19 Severe Accidents

As part of the AP1000 advanced design certification application, Westinghouse submitted a Probabilistic Risk Assessment (PRA) in accordance with the requirements of 10 CFR 52.47 and the Commission's "Policy Statement on Severe Reactor Accidents Regarding Future Designs and Existing Plants." The NRC staff's assessment of the AP1000 PRA consisted of the traditional evaluation of events that could lead to core damage and offsite consequences as well as an evaluation of what the PRA revealed about the AP1000 design.

Figure 19.1-1

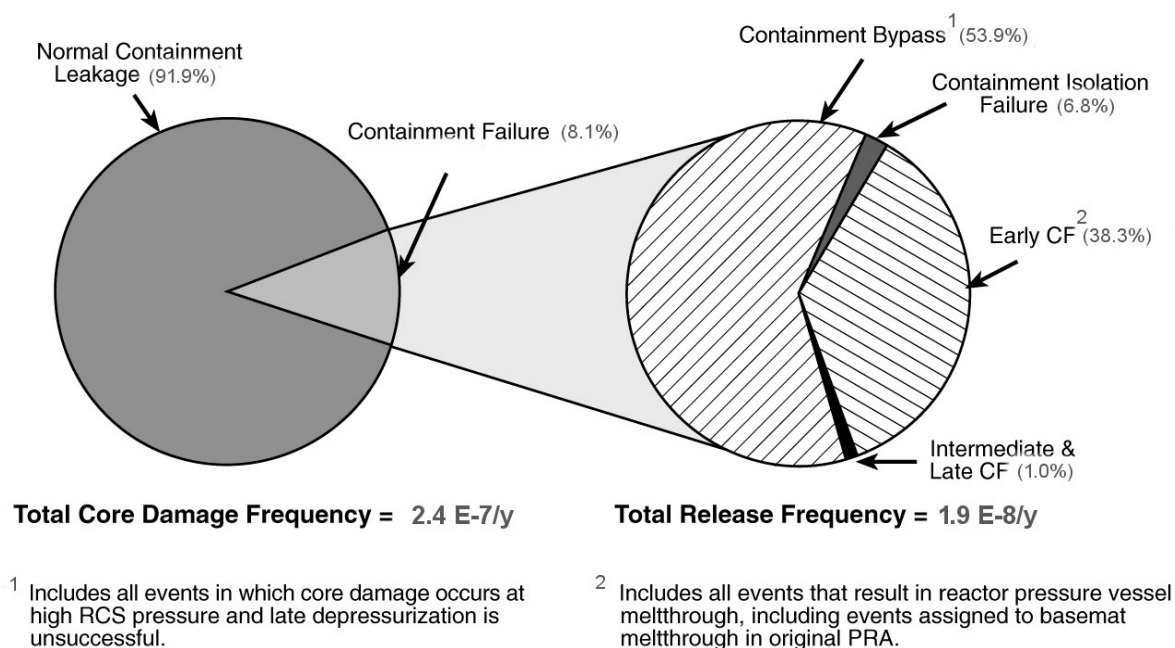
The frequencies of the various containment release categories and the fractional contributions by release category to the total large release frequency are presented in Figure 19.1-1 of this report and Table 19.1-4 of this report. The leading contributors to the various release classes are discussed further in Section 19.1.3.2.2 of this report.

Figure 19.1-2

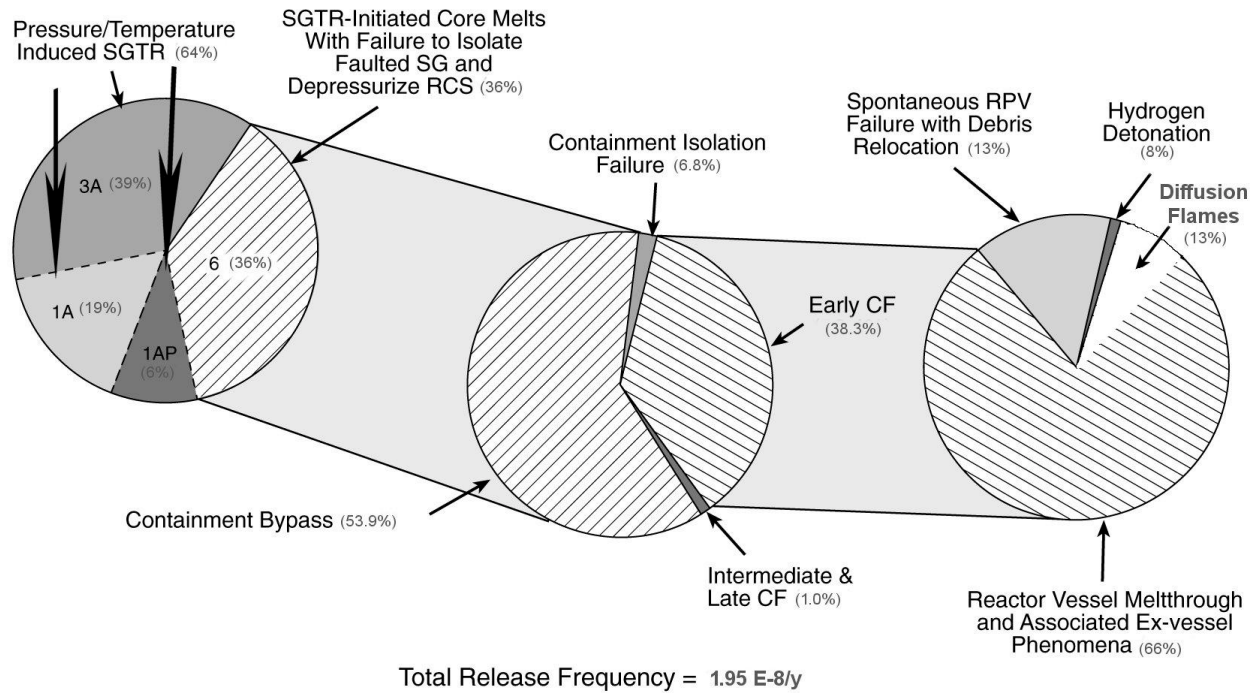
Important contributors to each of these release categories are identified in Figure 19.1-2, and discussed further in the sections that follow.

As shown in Figure 19.1-2 of this report, pressure and temperature-induced SGTR sequences account for 64 percent of the containment bypass frequency. High-pressure core melt

Figure 19.1-3
Overall Dose Risk
Site Boundary Whole Body EDE, 24 Hour Dose

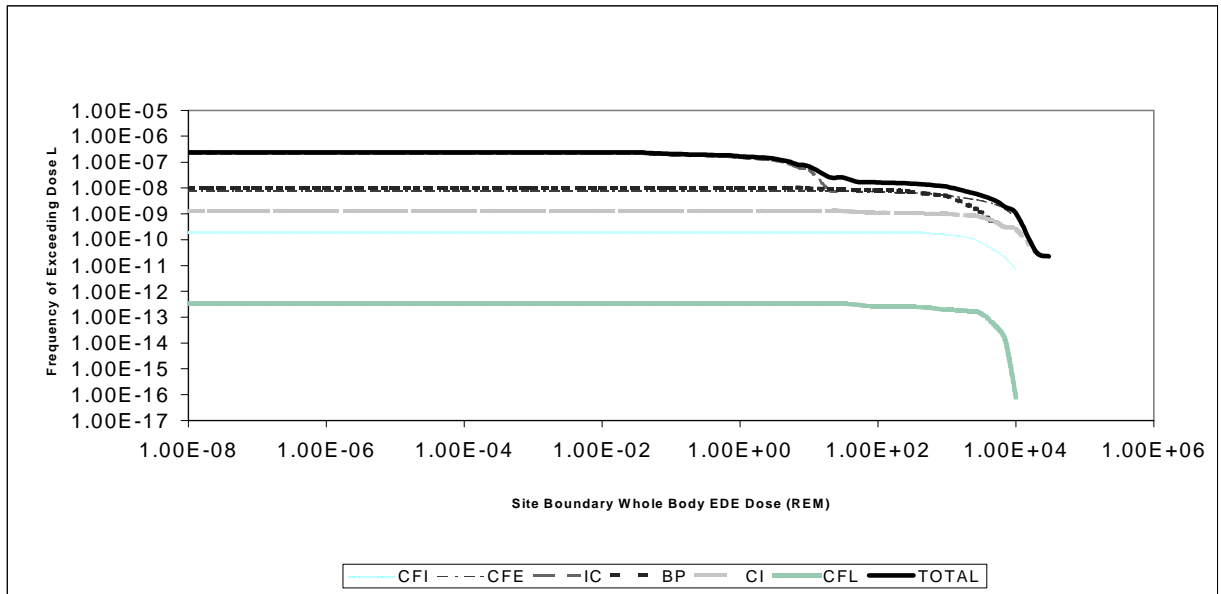
The contribution to risk from each of the release categories is presented in Table 19.1-5 and Figure 19.1-3 of this report. The following can be noted:

- Based on Figure 19.1-3, the probability of exceeding 0.25 Sv (25 rem) at the site boundary (0.8 km (0.5 miles)) is essentially flat and close to unity for all release categories except intact containment (IC). Thus, the probability of exceeding 0.25 Sv (25 rem) is equivalent to the probability of containment failure, or about $1.9\text{E-}8/\text{yr}$.
